## NOTICE OF DECISION

**Case File:** T2-03-083 (case number corrected)

**Permit:** Design Review and Sign Review

**Summary:** Design review for a restaurant and associated development approved in case T2-02-088 and request for a minor exception to the required front-yard for parking and placement of signage.

**Site plan**

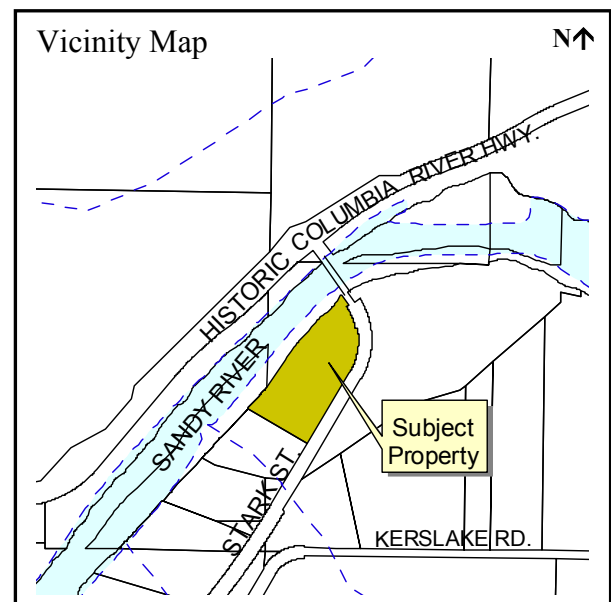
**Decision:** Approved with conditions a Design Review Plan, a Minor Exception for front-yard setback for parking and Sign Review.

7. Required parking and loading areas shall be shown on the building plans reviewed for the building permit. These plans shall show 67 parking spaces (MCC 11.15.6142). No parking related to the property shall be allowed along the Stark Street (MCC 11.15.6128). Traffic directions on access drives shall be plainly marked (MCC 11.15.6128). Parking spaces shall be marked (MCC
